PCN-20210216a TE0712-02 DDR3, Flash Change and Product Update (Revised)

Company	Trenz Electronic GmbH
PCN Number	PCN-20210216a
Title	TE0712-02 DDR3, Flash Change and Product Update
Subject	BOM change
Issue Date	(2021-02-17), Revised 2021-03-09

This change affects all Trenz Electronic TE0712 SoMs of revision 02: TE0712-02-*

#2 Replaced Flash (U4) to IS25LP512M-RHLE All SoMs use S25FL256SAGBHI20 Flash (U4)

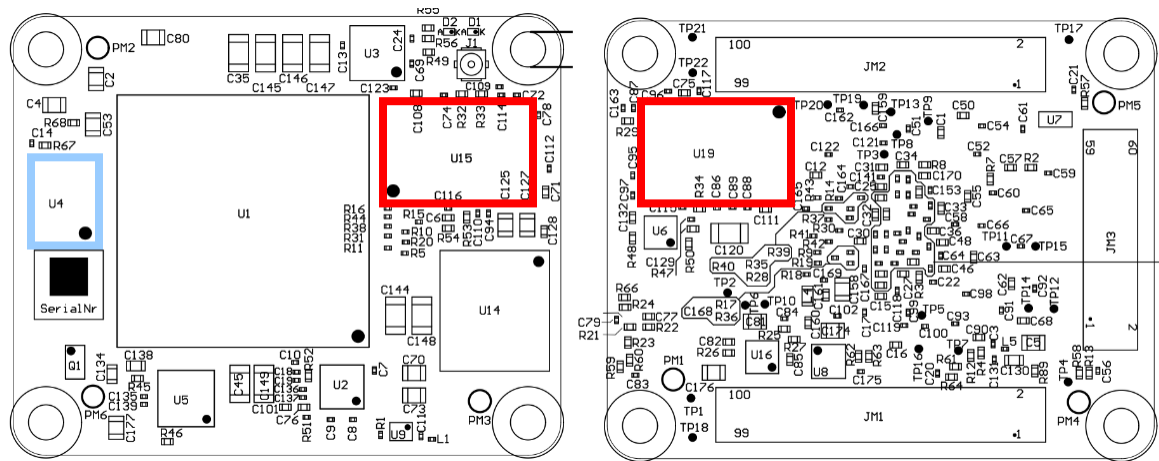
Type: BOM change
Reason: Ensure long time availability.
Impact: ~~Jedec Manufacturer ID changed from 01h to 9Dh, the device ID from 18h to 19h. 512Mbit flash are now available.~~

Type: BOM change
Reason: The planned IS25LP512M-RHLE is listed as 'Supported Flash Memory Devices for Artix-7 Device Configuration' in Xilinx UG908 (since version 2019.1), but there are unsolved problems with reboot after petalinux was started. Therefore this change is canceled. Only modules where other than S25FL256SAGBHI20 was used are changed to S25FL256SAGBHI20.
Impact: Jedec Manufacturer ID is 01h, the device ID 0219h. Size does not change, 256 Mbit flash are available.

Locate DDR3 RAM (U15 top, U19 bottom) and Flash (U4 top) on PCB:

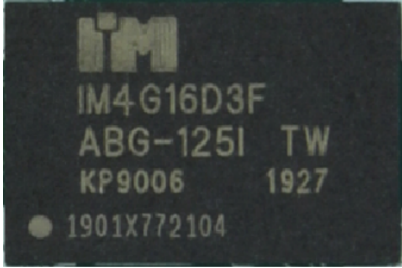
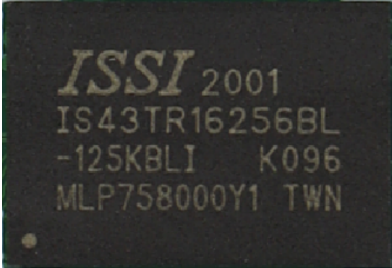
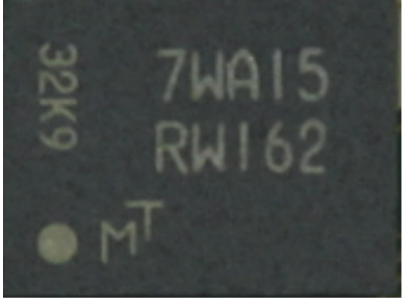
#1 Change DDR3 RAM (U15, U19) from IM4G16D3FABG-125I to IS43TR16256BL-125KBLI

#3 Clock Revision Change (U9) SiT8008AI-73-XXS-25.000000E to SiT8008BI-73-XXS-25.000000E

IM4G16D3FABG-125I	IS43TR16256BL-125KBLI

S25FL256SAGBH120 or MT25QL256ABA8E12-1SIT	IS25LP512M-RHLE
 TE0712-02-2CA and TE0712-02-72C03-M only:
